Enclosed for filing with the Commission and the new EDO please find two memoranda concerning the Vermont Yankee nuclear power station, docket number 50-271. My client, Citizens Awareness Network, Inc., requests that the Commission and EDO evaluate these documents, pursuant to 10 CFR 2.206, to see if enforcement action is warranted based upon the information contained therein.

DATE: December 5, 1996
TO: Vermont State Nuclear Advisory Panel
FROM: Citizens Awareness Network
RE: CAN'S analysis of Vermont Yankee's July 23, 1996 presentation on RHR minimum flow valve
CC: U.S. NRC and general release

Summary of CAN's Analysis of VY's Presentation, "RHR Minimum Flow Valve Enforcement Conference," (July 23, 1996).¹

DATE: December 6, 1996
TO: Vermont State Nuclear Advisory Panel
FROM: Citizens Awareness Network, Inc.
RE: Vermont Yankee Nuclear Power Station 1996 Licensee
Event Report Summary (May 1996 - October 1996).
CC: U.S. NRC and general release

System Diagram

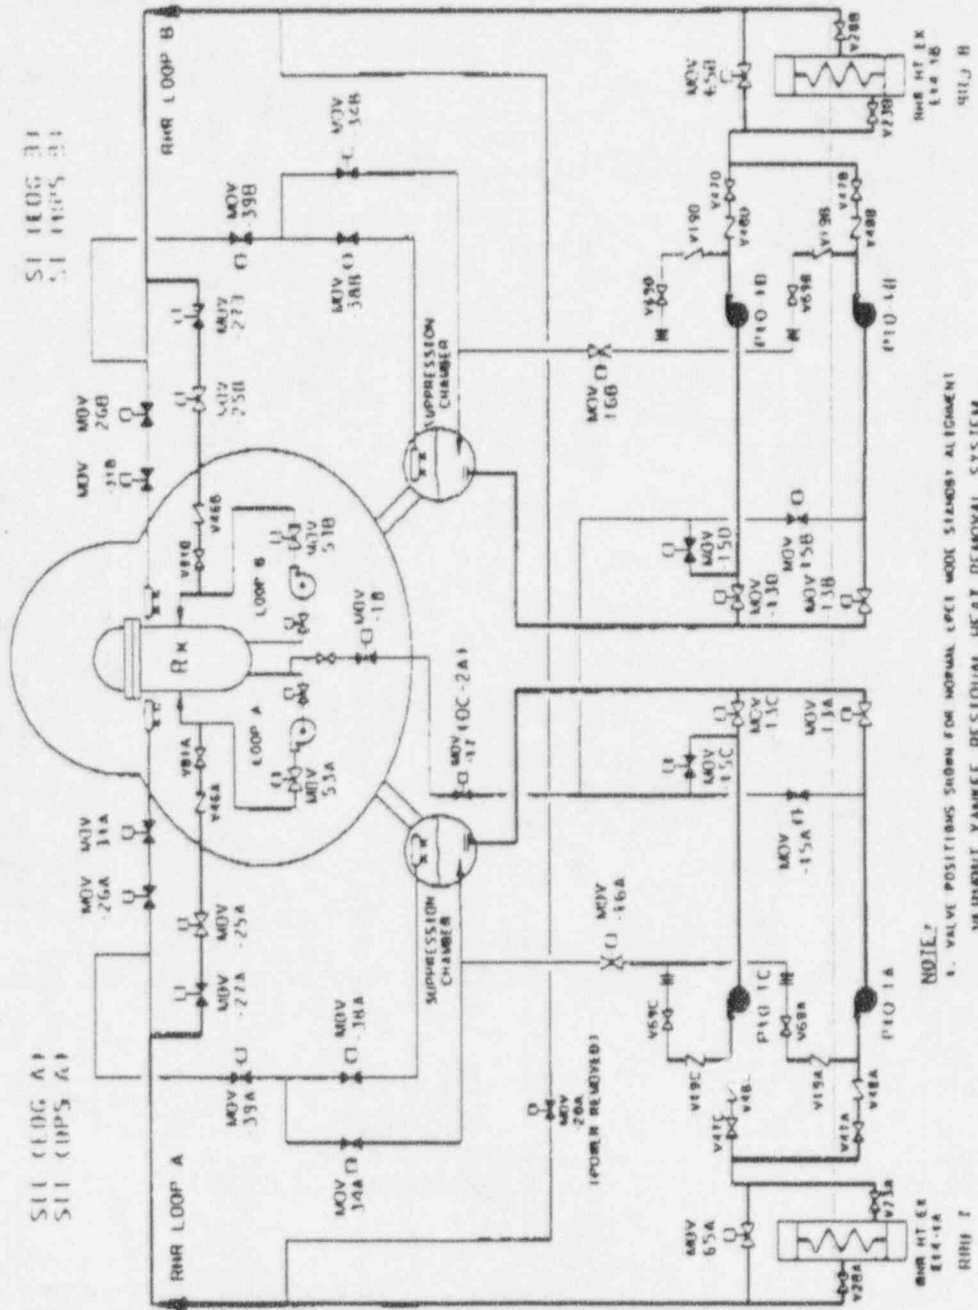
The RHR minimum flow valves (MOV-16A and MOV-16B) are shown on the slide "BACKGROUND SYSTEM DIAGRAM" to be the first isolation device on a line penetrating the suppression pool below the water line. Although it is not specified in the presentation slides, the RHR minimum flow valves probably have a containment isolation function. The RHR minimum flow valves at other boiling water reactor (BWR) plants of similar design (FitzPatrick, Browns Ferry, Peach Bottom, Hatch, etc.) perform a containment isolation function. Specifically, the RHR minimum flow valves must close to isolate the primary containment in the event of a pipe break outside containment.

When Vermont Yankee personnel changed the normal position of the RHR minimum flow valves from closed to open, they resolved the RHR pump protection problem. However, it is not certain that the containment isolation function of these valves was addressed. According to the slides "EXAMPLE CASE STUDY SINGLE FAILURE OF DC BUS 1 WITH LNP," the RHR minimum flow valves are normally open and fail open on loss of this power supply. With these valves now normally open, a single failure could prevent isolation of two containment penetrations.

In addition, the footnotes to these slides imply that the RHR minimum flow valves may not be provided with remote manual closure capability. Since the RHR minimum flow valves have dual function (to open on low pump flow for pump protection and to close for containment isolation), the operator in the control room must have the ability to override the automatic open signal to close the valves when necessary for containment isolation. In 1992, the New York Power Authority reported this exact deficiency to the NRC (LER 50-333/92-037-00 dated July 24, 1992).

In response to NUREG-0737 requirements, all licensees were required to evaluate containment isolation dependability following the Three Mile Island accident. It is imperative that the current configuration of the RHR minimum flow valves at Vermont Yankee be properly evaluated for containment isolation dependability, including remote manual closure capability.
